**Appendix I:
Transportation Supporting Information**

Final Memorandum

Date: March 29, 2021
To: Elizabeth Johnson, FCS International
From: Ashlee Takushi, Dhruvi Kothari, and Kathrin Tellez, Fehr & Peers.
Subject: Spotorno Ranch Focused Transportation Assessment

Figure 2 Proposed Project Site Plan

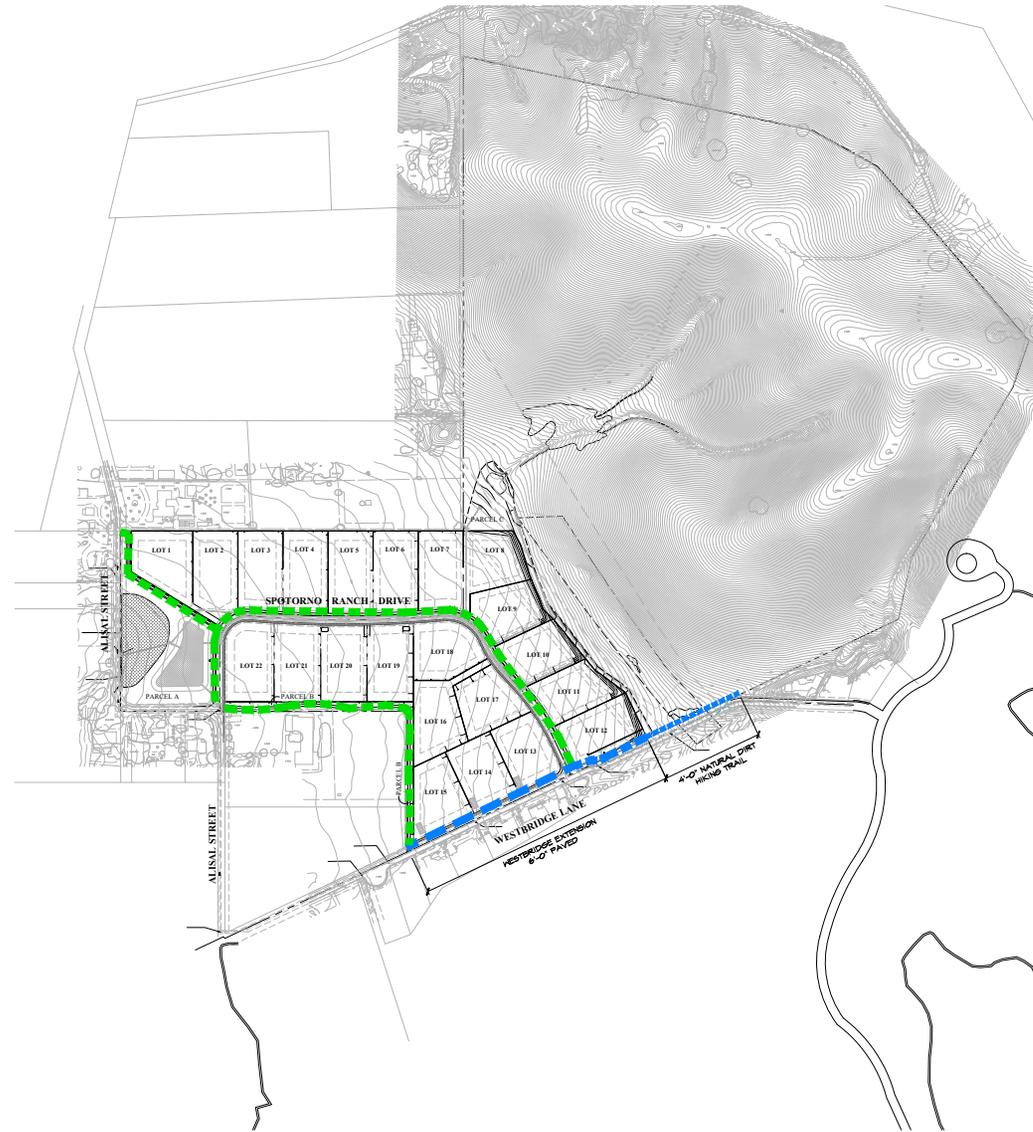
Recommendation 1: Consider reconstructing the future intersection Spotorno Ranch Road at Alisal Street such that the west leg of the intersection T's into the north-south leg. Consider providing stop control for vehicles traveling eastbound on Alisal Street or consider implementing an all-way stop-control. Signage should be installed on Alisal Street for vehicles traveling northbound to indicate that vehicles must turn left to remain on Alisal Street. New intersection lighting may need to be installed, consistent with the requirements in the Happy Valley Specific Plan that allows safety lighting to be installed at intersections.

Recommendation 2: At the future intersection of Spotorno Ranch Road at Westbridge Lane, install a stop-sign on Spotorno Ranch Road for vehicles turning to Westbridge Lane. Sufficient sight distance is currently provided, but any landscaping plans for this area should be reviewed such that future landscaping does not block sight distance.

The Happy Valley Specific Plan (HVSP) identifies 12-foot lane width as the preferred width for new roadways with the area, although 10 to 12 feet is permitted on some roadways. Insufficient information is provided on the conceptual plans to evaluate roadway widths.

Recommendation 3: Provide additional roadway design parameters of Spotorno Ranch Road for review. Although the Happy Valley Specific Plan identifies 12-foot travel lanes, those are typically for roadways without trails or sidewalks. Since Spotorno Ranch Road would provide a trail on one side of the street, and a sidewalk on the other, the added width of the travel lane to accommodate other travel modes could encourage higher vehicle speeds and the need for 12-foot wide roadways should be balanced against other Specific Plan goals.

Recommendation 4: Provide trail design details for review. Consider providing marked crosswalks at the new intersections of Spotorno Ranch Road at Alisal Street and Westbridge Drive.

Figure 2 Proposed Project Site Plan

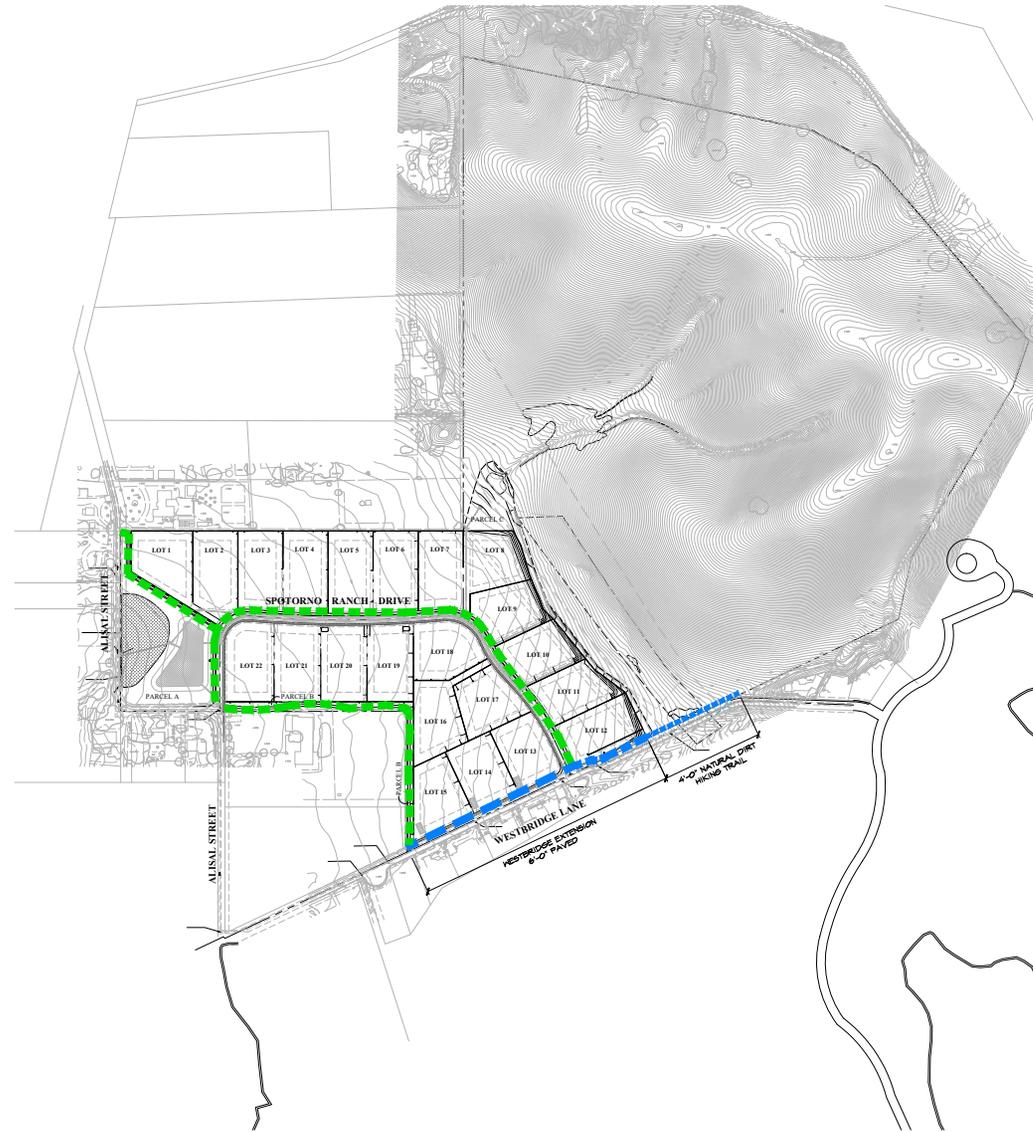
Recommendation 1: Consider reconstructing the future intersection Spotorno Ranch Road at Alisal Street such that the west leg of the intersection T's into the north-south leg. Consider providing stop control for vehicles traveling eastbound on Alisal Street or consider implementing an all-way stop-control. Signage should be installed on Alisal Street for vehicles traveling northbound to indicate that vehicles must turn left to remain on Alisal Street. New intersection lighting may need to be installed, consistent with the requirements in the Happy Valley Specific Plan that allows safety lighting to be installed at intersections.

Recommendation 2: At the future intersection of Spotorno Ranch Road at Westbridge Lane, install a stop-sign on Spotorno Ranch Road for vehicles turning to Westbridge Lane. Sufficient sight distance is currently provided, but any landscaping plans for this area should be reviewed such that future landscaping does not block sight distance.

The Happy Valley Specific Plan (HVSP) identifies 12-foot lane width as the preferred width for new roadways with the area, although 10 to 12 feet is permitted on some roadways. Insufficient information is provided on the conceptual plans to evaluate roadway widths.

Recommendation 3: Provide additional roadway design parameters of Spotorno Ranch Road for review. Although the Happy Valley Specific Plan identifies 12-foot travel lanes, those are typically for roadways without trails or sidewalks. Since Spotorno Ranch Road

would provide a trail on one side of the street, and a sidewalk on the other, the added width of the travel lane to accommodate other travel modes could encourage higher vehicle speeds and the need for 12-foot-wide roadways should be balanced against other Specific Plan goals.

Recommendation 4: Provide trail design details for review. Consider providing marked crosswalks at the new intersections of Spotorno Ranch Road at Alisal Street and Westbridge Drive.
